CAA Environmental Assessment

Airspace Trial

Title of airspace change proposal	CAELUS Trial C – Ayrshire and Arran
Change sponsor	AGS Airports Ltd
Project reference	ACP-2022-103
Account Manager	██████████
<p><i>Instructions</i></p> <p>In providing a response for each question, please ensure that the ‘status’ column is completed using the following options:</p> <ul style="list-style-type: none"> • YES • NO • PARTIALLY • N/A <p>To aid the decision maker, highlight each question accordingly to illustrate what is:</p> <p>resolved YES not resolved PARTIALLY not compliant NO</p>	
<h3>1. Introduction</h3> <p>AGS Airports Ltd (sponsor) submitted an Airspace Change Proposal (ACP) for a temporary change to airspace design to allow the delivery of a Concept of Operations (ConOps) for the transition to fully integrated Unmanned Aircraft (UA) at a national level. The sponsor intends to utilise volumes of segregated airspace in the vicinity of Prestwick Airport in the Ayrshire and Arran region to prove elements of their proposed future concept of integrated airspace allowing Remotely Piloted Aircraft Systems (RPAS) Beyond Visual Line of Sight (BVLOS) operations to transport essential medicines,

Figure 3: Population density map with flight routes overlaid

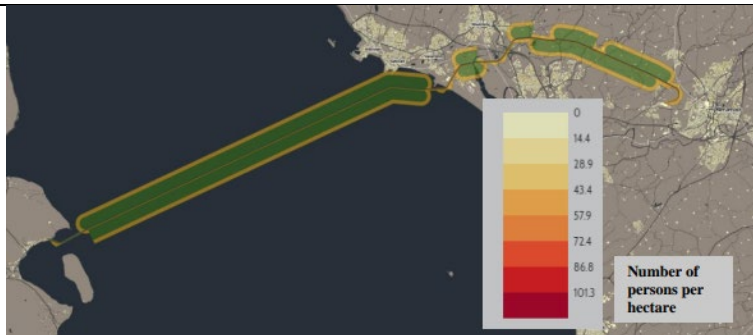
<p>The change sponsor has provided typical noise data for the Swoop Kookaburra Mk III RPAS. The UAS to be used in respect of this ACP is the next generation Swoop aircraft, the Kite which the sponsor has indicated is designed very similarly to the Kookaburra (fixed-wing, Vertical Take-off and Landing (VTOL) and noise impacts are considered to be similar. On this basis, the sponsor indicates that the noise levels (maximum spot point noise levels, L_{ASmax}) from the RPAS are expected to be:</p> <ul style="list-style-type: none"> • 76dB L_{ASmax} during take-offs and landing (86dB L_{ASmax} considering a noise penalty of 10 dB) • 49dB L_{ASmax} during cruising at a height of 200ft above ground level (59dB L_{ASmax} considering a noise penalty of 10 dB) <p>The noise penalty has been added to take account of tonal frequencies associated with multi-rotor UAS in line with CAA guidance.</p> <p>The sponsor states that the UA is a hybrid-powered lift transitional platform which takes off and lands vertically and under normal circumstances will cruise at a height of 400ft above ground level. Typical L_{ASmax} at this altitude have not been provided, however, taking into account the reduction of sound intensity over distance, the predicted noise level on the ground is likely to be less than 59dB L_{ASmax}, considering the noise penalty.</p> <p>The sponsor mentions that take-off and landing, which constitutes the most impactful part of the operation in terms of noise, typically takes 17.57 seconds at standard climb/descend rate, and 8.98 seconds at maximum climb/descend rate.</p> <p>In the final submission, the change sponsor has provided maps with the proposed RPAS route plotted on population density charts to illustrate the take-off, landing and routing of the RPAS (Figure 2) and maps showing the identified noise sensitive receptors near the TOLPs (Figures 3 to 5). However, there are inconsistencies in the document the sponsor needs to address, such as alignment between text and numbering of figures, pointing out the correct position of the TOLPs and referring to information only relevant to this final version of the ACP.</p>

- Inconsistencies in the document, such as alignment between text and numbering of figures, pointing out the correct position of the TOLPs and referring to information only relevant to this final version of the ACP (par. 33, fig.4, fig.5, par.35)

Figure 3: Arran TOLP (Field Near Arran Outdoor Centre) and distance from nearest sensitive noise receptors (left) and arrival/departure route to/from Arran TOLP (right)
 Note that the red dot on the right figure does not point out the position of the TOLP indicated on the left figure.

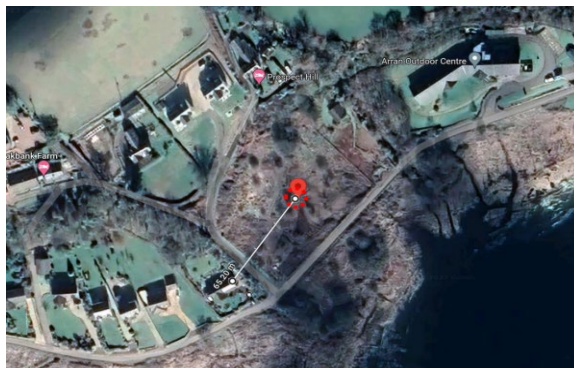
- The Arran TOLP is shown to be located in a field next to the Arran Outdoor Centre (Figure 3). The nearest noise receptors are identified as residential buildings approximately 65 m to the west and 75-80 m north of the TOLP.
